Range SA Large Regional	Model W100	N° T.I. 18_2025
Serial Number 52420750	Subject Added TWO RUBBER PADS on the LOWER DOOR COVER

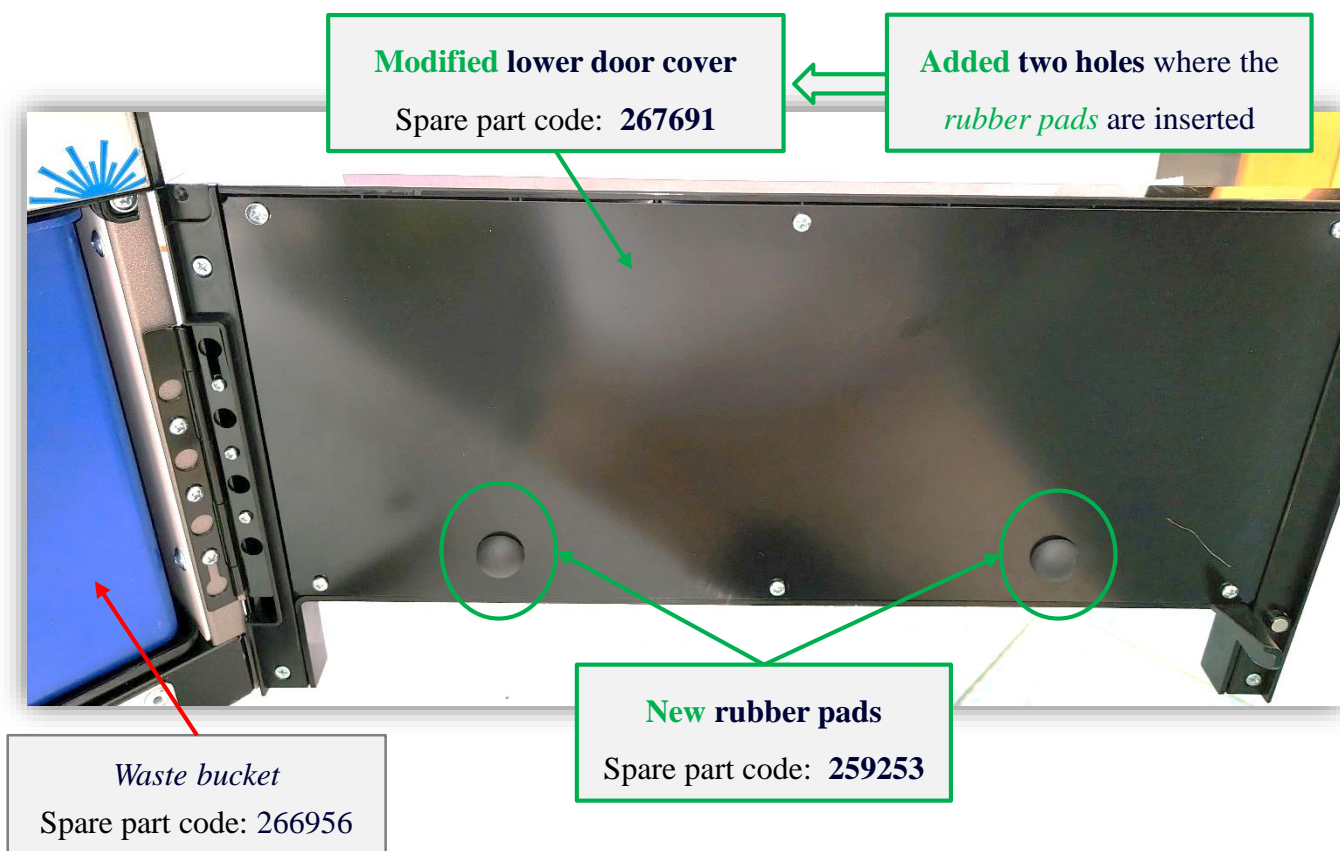
Be informed that with the aim to guarantee the proper position of the *waste bucket* (spare code: **266956**)

Two rubber pads have been added on the *lower door cover*

For machines previous to above S/N it is possible introduce the **new solution**, by ordering:

1. **N. 2 rubber pads** - spare code: **259253** sap:55128386
2. **N. 1 modified lower door cover** - spare code: **267691** sap:55128421
